Model
**1998
ACCORD**

Bulletin No.
98-056

Inaccurate Fuel Gauge

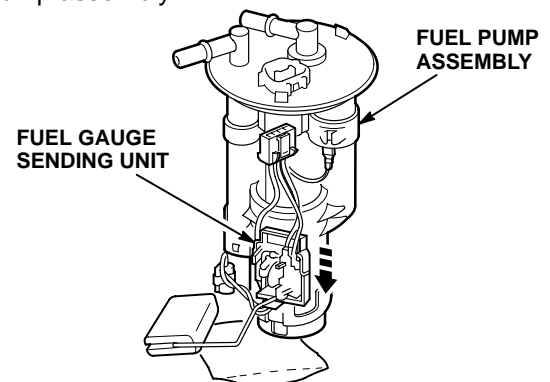
6. Remove the fuel gauge sending unit from the fuel pump assembly.

7. Install the new fuel gauge sending unit on the fuel pump assembly by placing it against the assembly and sliding it up until it locks in place.
8. Reinstall the fuel pump assembly in the fuel tank, and reconnect the electrical connector and lines. Torque the mounting bolts to 4 N·m (3 lb-ft).
9. Reinstall the access cover and the trunk floor.
